UNITED STATES PATENT AND TRADEMARK OFFICE

Office Action Summary	Application No. 10/563,954	Applicant(s) PFEIFFER, WERNER	
	Examiner /Robert James Popovics/	Art Unit 1797

DETAILED ACTION

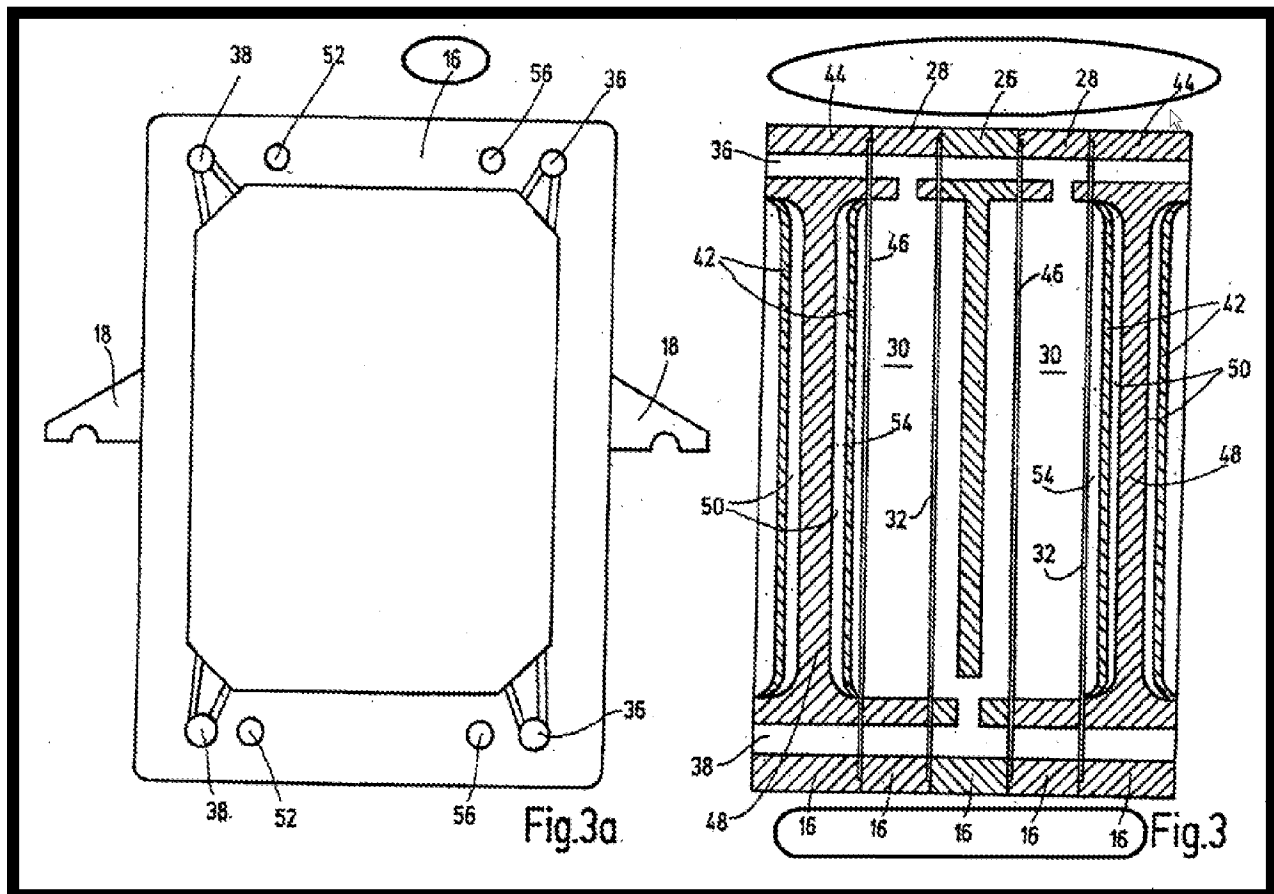
The recitation ***“arranged in sets thereof”*** does not appear in the originally filed specification. Moreover, referencing the specification and drawings to ascertain the meaning of this recitation in the context claimed revealed the use of the same reference numerals to designate the same part as outlined below.

The drawings are objected to as failing to comply with 37 CFR 1.84(p)(4) because reference characters **"44," "28," "26" and "16"** have all been used to designate the same part:

Corrected drawing sheets in compliance with 37 CFR 1.121(d) are required in reply to the Office action to avoid abandonment of the application. Any amended replacement drawing sheet should include all of the figures appearing on the immediate prior version of the sheet, even if only one figure is being amended. Each drawing sheet

Saito Patent with Arrows Clearly Depicting Flowpaths

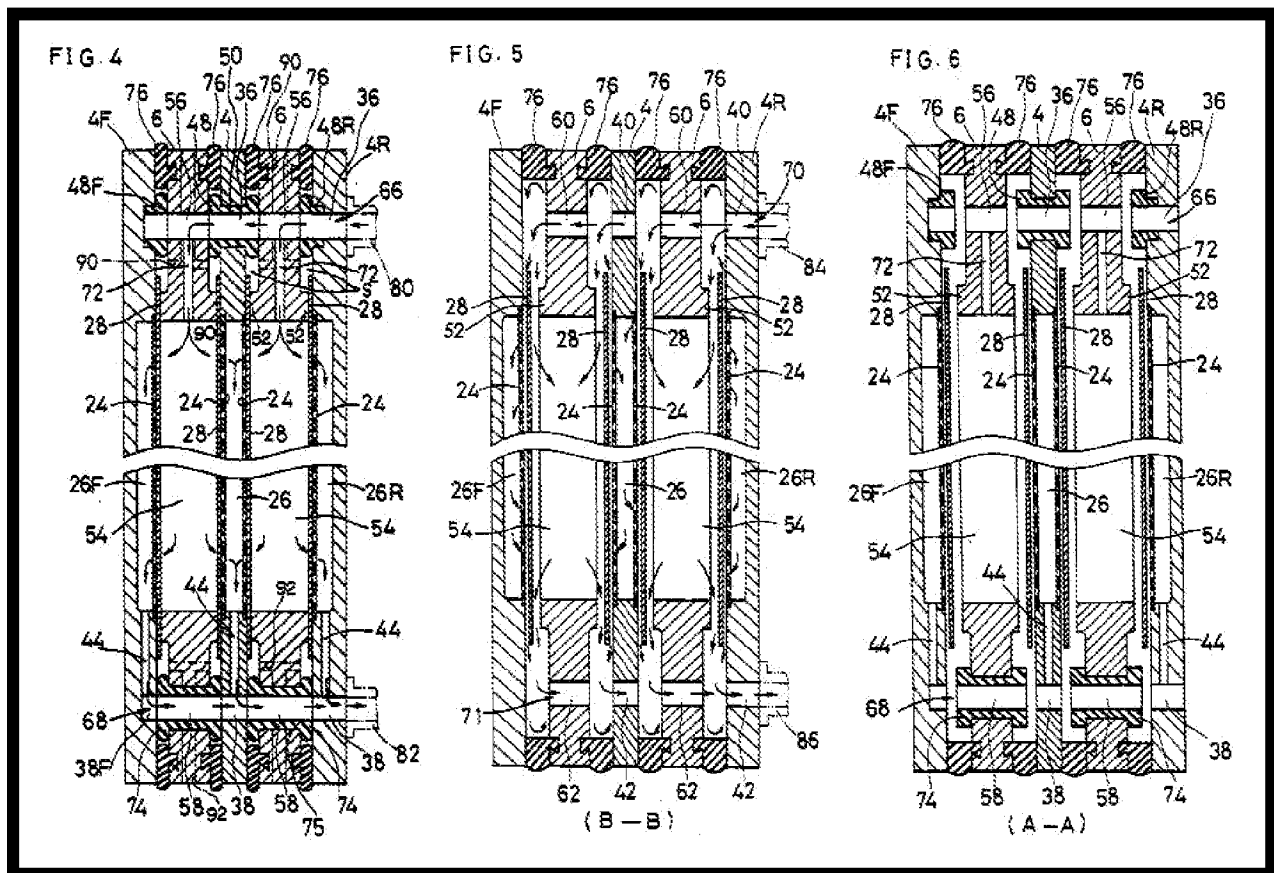
Support in the originally filed specification could not be found for the recitation, ***“feeding a washing fluid sequentially through each set of the second filter mediums, the filter cakes and the laminar filters in that order.”*** In this regard, the drawings and specification were of little help, as the flowpaths now claimed are not depicted.

The drawings are objected to under 37 CFR 1.83(a). The drawings must show every feature of the invention specified in the claims. Therefore, the **claimed flowpaths** must be shown or the feature(s) canceled from the claim(s). **Note the arrows depicting the flowpaths in the illustrations of SAITO (US 5,362,387) below.**

No new matter may be entered.
